**TRANSMITTAL OF UNPUBLISHED PEER REVIEW REPORT**

REPORT OF THE PEER REVIEW PANEL  
ON THE  
PROPOSED PROGRAM OF STUDIES OF THE  
CALCITE AND OPALINE-SILICA DEPOSITS  
IN THE YUCCA MOUNTAIN AREA  
NEVADA

June 18, 1987

TABLE 1. FLOW PLAN FOR INVESTIGATIONS OF  
THE CALCITE AND OPALINE-SILICA VEINS

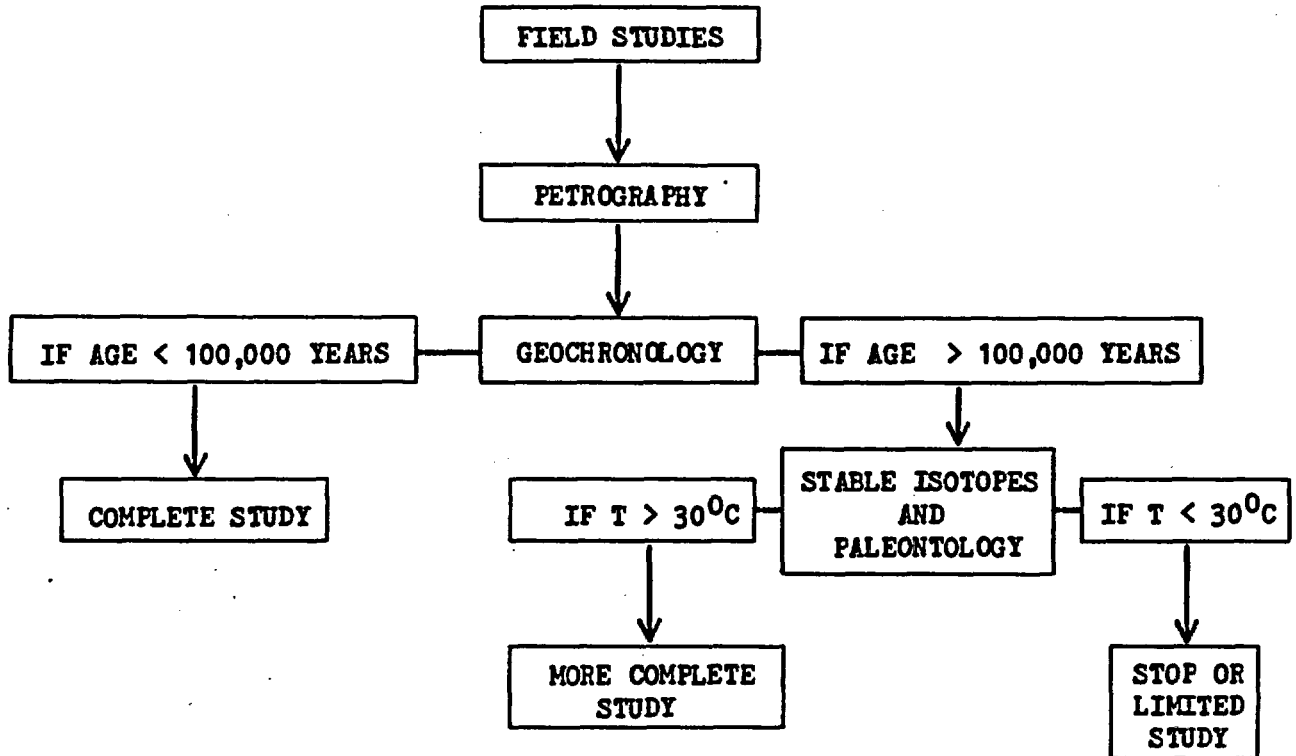
We recommend that field, petrographic, geochronological, stable isotope, and paleontological studies be undertaken at each site. Table 1 shows a plan for studies at each site. These studies are most important for: (1) helping to determine the age of the vein and breccia deposits associated with faulting; (2) placing constraints on time intervals between fault movements on a given fault assuming new veins are introduced at, or near, the time of faulting; (3) determining the temperature of waters responsible for the vein deposits; and (4) determining the origin of the veins and breccia. If the veins are young (i.e., less than 100,000 years old), a more complete study, including mineralogy; fluid inclusions; major, minor, and trace element; and tracer isotopes studies will be required. If the veins are old (i.e., greater than 100,000 years) and formed from cold waters, no further studies may be warranted. If the veins or breccias are old (i.e., greater than 100,000 years) and from hot waters, some limited mineralogical and geochemical studies may be warranted.

It is very clear that close cooperation among all researchers is essential at all stages of this Project, both because there is interdependence among the various approaches to be used and because the later parts of the research will depend on the results of the earliest and most important studies (see Table 1). Most obviously, if the calcite and opaline-silica veins turn out to be young (less than 100,000 years) a great deal more effort will be needed to determine their origin and the path of movement of the water that deposited them than would be the case if they are old.
